TITLE SCHEMATIC ERROR ON LOGIC SCHEMATIC 103684				PIB NO. DK3034	
PRODUCT LINE	TAPE DISK FORMATTER	EQUIPMENT CHANGED Logic Schematic 103684	MODEL SERIES AFFECTED D3000	EFFECTIVE DATE 5/16/75

D3000, DIABLO compatible, option 046, drawing errors. This Product Improvement Bulletin provides the necessary information to correct the Revision C, 103684 Logic schematic.

103684, Sheet 2, Zone E/4

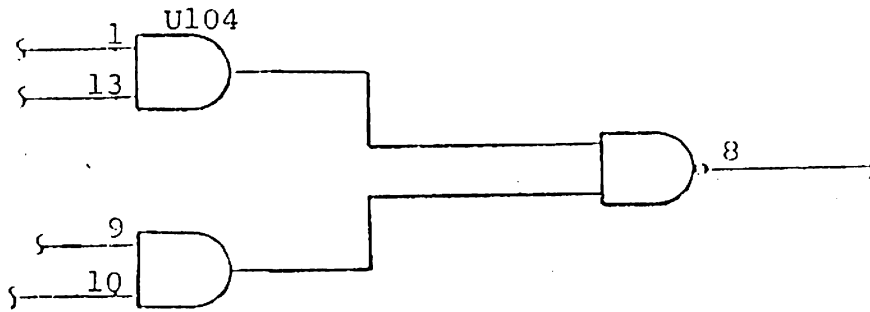
DRAWING CHANGES:

103684, Sheet 3, Zone B/8

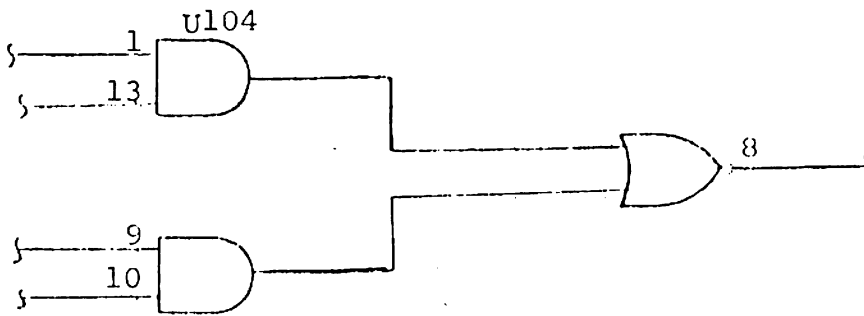
From

To
